INITIAL FIRE SAFETY INSPECTION REPORT

Ananta Casual Wear Ltd. (Extension)

RSC ID: 26359

Date: 03-July-2025

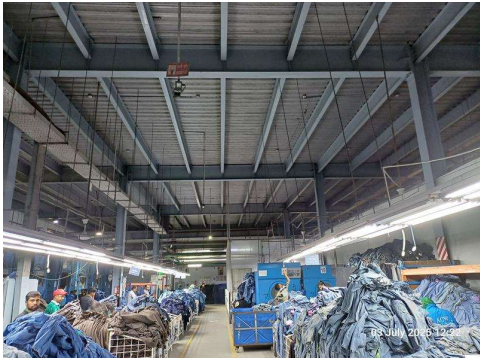
SI No.	Category	Findings	Required Action	Remediation Time Frame
F-01	Fire Rated Construction	Areas used for in-process storage of combustible materials are open to the surrounding occupancy. Location: Ground floor and first floor of laundry building.	Provide defined storage areas and limit the storage arrangement as follows: Maximum height of 2.45 m and maximum area of 23 m² and is separated by a minimum 3.0 m (10ft) from other storage areas and they do not exceed 10 percent of the building area of the story in which they occur. or, If sprinkler protected, Maximum height 12 ft (3.66 m) and maximum area of 1000 ft² (93 m²) and separated by a at least 25 ft (7.62 m) and does not constitute more than 10 percent of the building area or 4000 ft² (372 m²) of the sprinklered area, whichever is greater. or, Enclose the storage area from the surrounding occupancy with a minimum 1 hour construction.	Within 3 Months

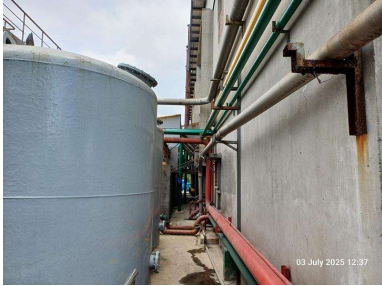
F-07	Fire Rated Construction	The main structural element of the interim building is constructed by steel which is non-rated and were found in exposed condition without any fire protection. Location: Laundry building.	The construction type is unprotected steel construction. As per RSC Technical Guideline and BNBC 2006, The Fire rating of the structure requires to be confirmed as per BNBC 2006. The "Ministry of Housing and Public Works" has issued a resolution based on the recommendations from the House Building Research Institute (HBRI) and the Public Works Department (PWD) to assess structural fire protection requirements of steel buildings (unprotected non-combustible construction type) according to BNBC 2020. The construction type shall confirm to be in accordance with BNBC 2020 Part-3, Table 3.1.7. Ensure fire resistive rated construction following Table 3.3.1 (a) Part 3 Section-3, Table 3.2.2 and Table 3.2.3 Part 3 Section 2 and Table 4.1.1 from BNBC 2020 Part 4 Section 1. Provide design philosophy to determine the construction type as per BNBC 2020. If any construction rating requires, Consult a qualified fire protection engineer to achieve the required fire rating. Submit the design philosophy along with the required documents to RSC for review the required construction type. Once the design philosophy is reviewed, provide fire ratings of structural members.	Within 6 Months

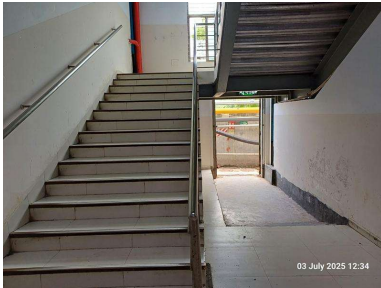
F-08	Fire Rated Construction	The required fire separation distance for "Laundry Building" does not comply with the requirements of BNBC 2006	The exterior walls shall have a fire resistance and opening protection as specified in BNBC 2006, Tables 3.2.2 and Part 3 Section 2.4.1.3.	Within 6 Months
